Air Quality Permitting Response to Public Comments

**Permit to Construct No. P-2015.0051
Project 61598**

**Alta Mesa - ML Investments 1-3
Payette, Idaho**

Facility ID No. 075-00024

Attachment 1

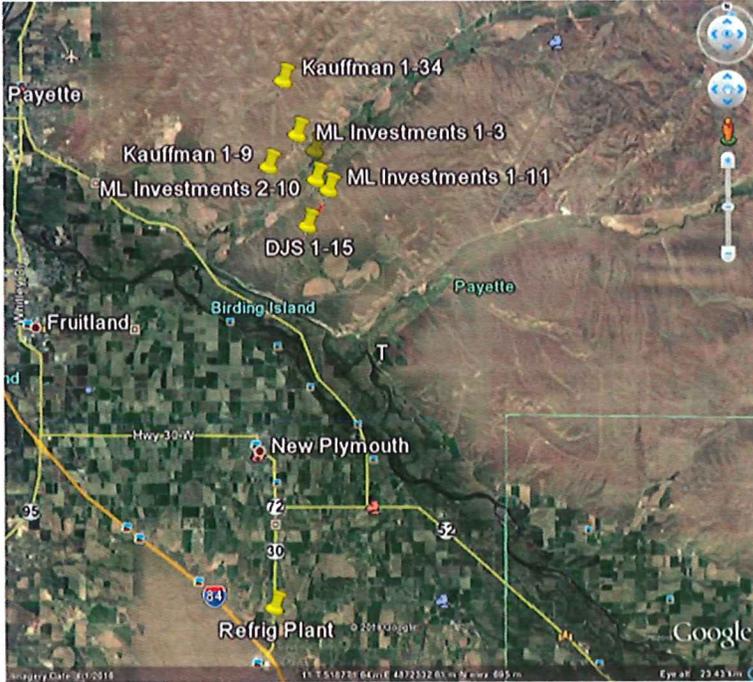
Comment 2: This PTC is for one of six wells located within the Little Willow Creek Valley, located roughly 5 miles from the city of Payette, ID (Attachment 1). We strongly encourage DEQ to aggregate emissions from this well with all of the current or future wells within this valley. DEQ's air impact modeling results highlight that emissions from these well sites have broad dispersions, impacting air quality up to 7 miles away from the source (Attachment 2: Figure 1 from DEQ's Modeling Memorandum). The emissions from these wells will undoubtedly combine in the atmosphere and have a cumulative impact greater than what is predicted by solely analyzing each well site as an individual entity. Treating each well site does not capture the whole picture, and may inadvertently fail to predict harmful air quality violations as a result of cumulative impacts.

This PTC is for one of six wells located within the Little Willow Creek Valley, located roughly 5 miles from the city of Payette, ID (Attachment 1). We strongly encourage DEQ to aggregate emissions from this well with all of the current or future wells within this valley. DEQ's air impact modeling results highlight that emissions from these well sites have broad dispersions, impacting air quality up to 7 miles away from the source (Attachment 2: Figure 1 from DEQ's Modeling Memorandum). The emissions from these wells will undoubtedly combine in the atmosphere and have a cumulative impact greater than what is predicted by solely analyzing each well site as an individual entity. Treating each well site as a solitary source does not capture the whole picture, and may inadvertently fail to predict harmful air quality violations as a result of cumulative impacts.

Response 2: Based on the definition of facility as defined in the Rules for the Control of Air Pollution in Idaho, all three indicators identified in the definition of “facility” must be met for all of the pollutant-emitting activities to be considered one facility. These three indicators are common control, industrial grouping, and contiguous or adjacent properties.

On May 12, 2016, the U.S. Environmental Protection Agency (EPA) issued the Source Determination Rule to clarify permitting requirements for the oil and natural gas industry. EPA issued the rule to clarify when multiple pieces of equipment and activities in the oil and gas industry must be deemed a single source. The final rule defines the term “adjacent” to clarify that equipment and activities in the oil and gas sector that are under common control will be considered part of the same source if they are located on the same site, or on sites that share equipment and are within ¼ mile of each other. DEQ incorporates by reference EPA rules, including aggregation of emissions for the oil and gas industry.

Although the ML Investments 1-3 well-site is only about 0.15 miles of the proposed Alta Mesa ML Investments 2-3 facility, it does not share equipment with other well-sites and is therefore not considered as part of any other facilities.

DEQ also disagrees with the comment stating that emissions from this site should be aggregated with all current or future wells within this valley when evaluating the air impacts. Within approximately 0.4 miles, design value (equal to the 5-year average of upper 98th percentile impacts of the annual distribution of maximum daily 1-hour impacts, consistent with the form of the 1-hour NO₂ standard) drops to levels below 5 µg/m³. Within about 2 miles, design value impacts drop to levels below 1.0 µg/m³ at most locations.

DEQ analysts, responsible for evaluating air impact analyses of potential emissions from facilities applying for air emissions permits, performed a verification analysis of NO₂ impacts from the ML Investment 1-3 facility with emissions included from the potentially co-contributing ML Investment 2-3 facility that is within about 0.15 miles from the ML Investment 1-3 facility. Although the presence of the neighboring ML Investment 2-3 did affect the modeled design value at receptors near that facility, it did not change the modeled maximum design value. This result was expected. The plume of the two sources must overlap almost exactly during a period when the primary source has relatively high impacts to enable a measurable co-contributing impact for a 1-hour averaging period.

**Figure 1: Concentration Contours in Micrograms per Cubic Meter
for 1-Hour NO₂ Design Value Impacts
Background Concentrations not Included**

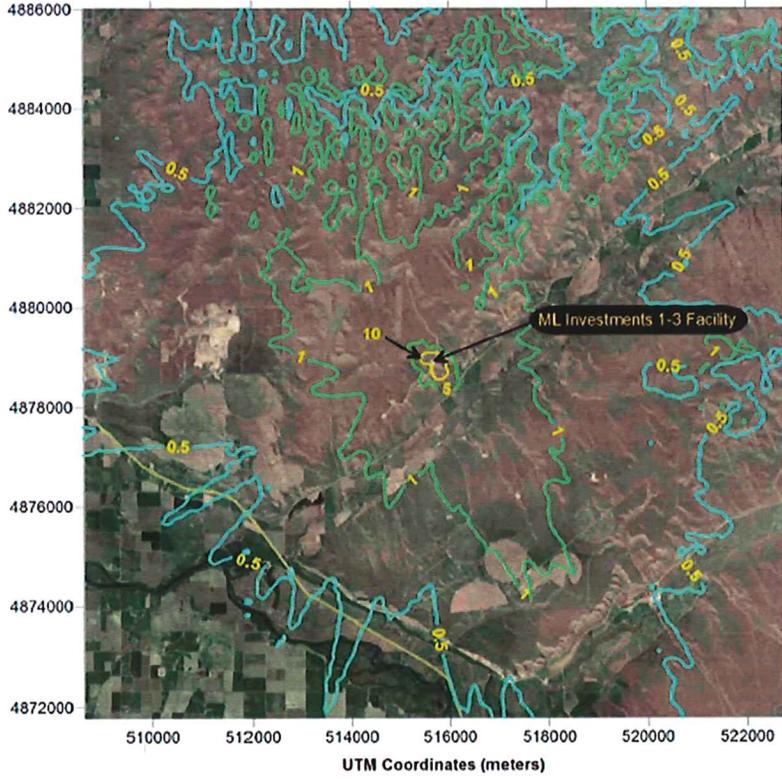
Results from NAAQS impact modeling for this well indicate that emissions from this source will span roughly 7 miles (Attachment 2). The majority, if not all of these wells will reside within the 1 µg/m³ increase in 1-hour NO₂ contour. As a result portions of the valley within the immediate vicinity of all of these wells will experience at a minimum an increase in 1-hour NO₂ concentrations of 6 µg/m³, bringing background concentrations for 1-hour NO₂ up to at least 58.6 µg/m³. This increase could have serious implications if wells have total maximum concentrations modeled close to the NAAQS threshold.

Results from NAAQS impact modeling for this well indicate that emissions from this source will span roughly 7 miles (Attachment 2). The majority, if not all of these wells will reside within the 1 µg/m³ increase in 1-hour NO₂ contour. As a result portions of the valley within the immediate vicinity of all of these wells will experience at a minimum an increase in 1-hour NO₂ concentrations of 6 µg/m³, bringing background concentrations for 1-hour NO₂ up to at least 58.6 µg/m³. This increase could have serious implications if wells have total maximum concentrations modeled close to the NAAQS threshold.

Response 3: ICL is concerned that the background pollutant concentration value used in the 1-hour NO₂ impact analysis does not account for increases in pollutant emissions from other oil and gas wells in existence or planned for the area. DEQ staff contends that the contribution of such sources to an area-wide background concentration is negligible and definitely below the quantitative uncertainty in the background value used. NO_x emissions will be less than 8.0 ton/year, with maximum hourly emissions at 1.3 pounds/hour. At these rates, DEQ is confident that collective impacts to the airshed are inconsequential.

DEQ's permit air impact modeling program requires modeling the permitted facility and any nearby co-contributing sources that have a high probability of affecting the maximum design value impact of permitted facility, considering the magnitude of emissions and distance from the permitted facility. A regionally applicable background concentration, based on monitoring data or a combination of regional scale modeling and monitoring data, is then added to the maximum modeled design value. The background value used for short-term standards is very conservative since it is also reflective of the design value impact rather than a long term average concentration. The final design value impact of the permitted facility (design value modeled impact of emissions from the permitted facility and potential nearby co-contributing sources added to the design value background concentration) could only be realized if the modeled design value impacts occur simultaneously with the design value background concentration. In most cases, this is not likely.

Nearby minor sources (less than 100 ton/year of emissions of any specific pollutant) have a higher potential impact as a co-contributing source, to be modeled explicitly with the permitted source, than as a contribution to the regional background. The potential for nearby well sites to contribute to the modeled design value impact was addressed in DEQ's response to Comment 2.

The modeled design value contour maps for the Kauffman 1-9 and DJS 1-15 facilities cannot be interpreted as an appropriate contribution to general background pollutant levels. The design value is based on the 8th highest value of daily maximum 1-hour concentrations. For this value to contribute to design value impacts of other facilities, the impacts would need to coincide in time and space with the impacts of other facilities and periods of high regional background concentrations. This is highly unlikely.
